15-34. HYDROGEOLOGY AROUND TSF

Concern:

Figure 1: Groundwater levels. Source: (R. W. Corkery & Co. Pty. Limited, 2020, pp. 5-171)

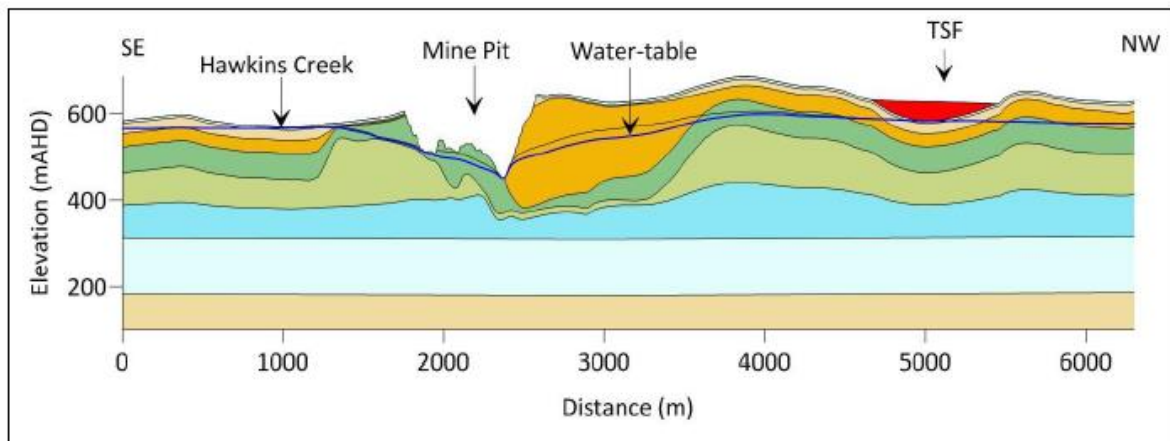
(Jacobs (Australia), 2020, pp. 5-171) reports up to 8 m of groundwater mounding in the aquifer around the TSF which implies hydraulic connectivity between the TSF and the aquifer. At the scale presented, mounding beneath the TSF is not evident on the southeast to northwest section line presented in Jacobs 2020 (Figure 1 below). If anything, the inferred groundwater flow gradient beneath the TSF in Figure 1 appears to slightly slope to the northwest, rather than towards the pit lake as reported. The fate of the leachate (seepage) is unclear both during and post mining.

Figure 1 shows the course level of hydrogeological interpretation around the TSF along the SE-NW transect. A corresponding SW-NE transect is recommended, as this would show the location of faults relative to site infrastructure. Faults, as well as the hydraulic conductivities and thicknesses of the layers play a part in how quickly leachate is transmitted through the aquifer to impact significant receptors. The layers are not labelled with their hydraulic conductivities, however, even at the scale of Figure 1, a change in layer thicknesses under the TSF are anticipated.

Figure 2: Paired well hydrographs – Figure 27 in (Jacobs (Australia), 2020, pp. 5-94)

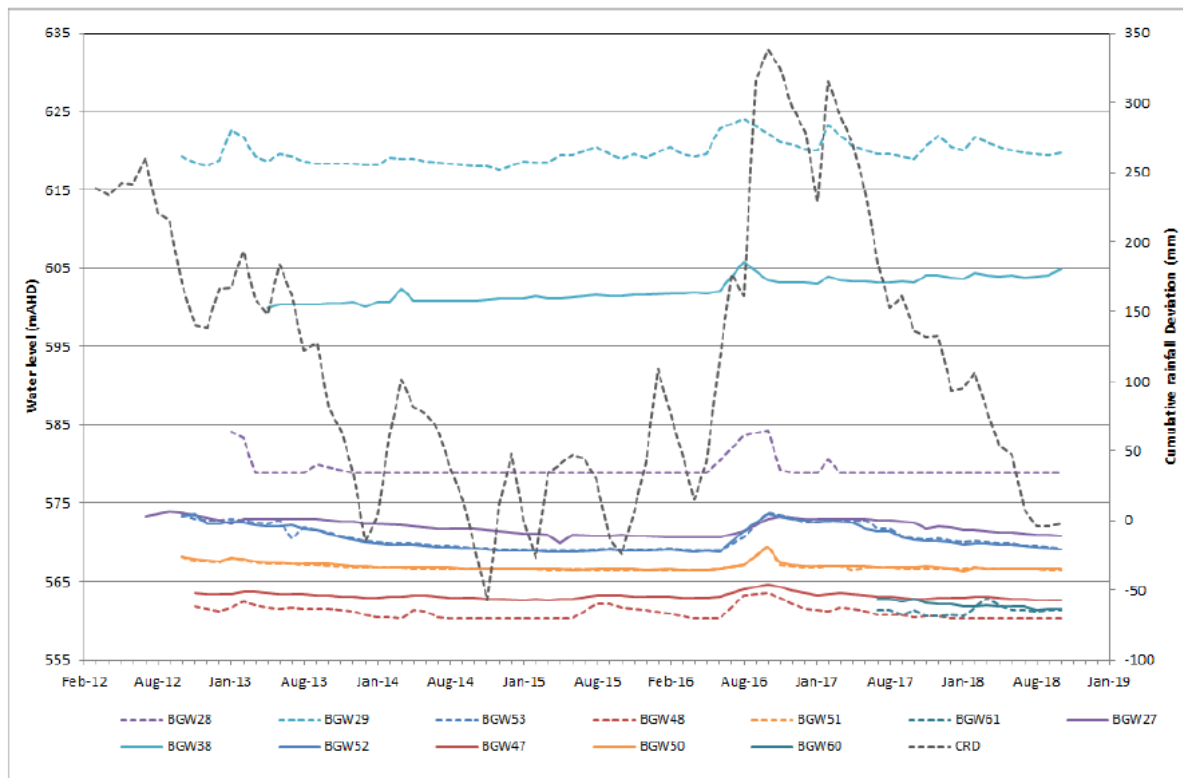
The 'paired bores' drilled to investigate vertical conductivity for infiltration rates could provide some justification of the hydrogeology. BGW47/49 (some distance apart) show an upwards hydraulic gradient with some resistance to flow, while BGW50/51 and BGW60/61 (near the TSF) shows little evidence of any resistance to vertical flow.

From July 2017 to January 2018, BGW60/61 (near the proposed TSF) showed evidence of some barrier to vertical flow. This resistance or barrier is not evident after January 2018. Exploration drill holes approved under mining legislation have less stringent backfilling requirements than bores but may create new conduits for vertical groundwater flows. Powers under Section 324 of the WMA 2000 can be used to manage local impacts on existing groundwater works.
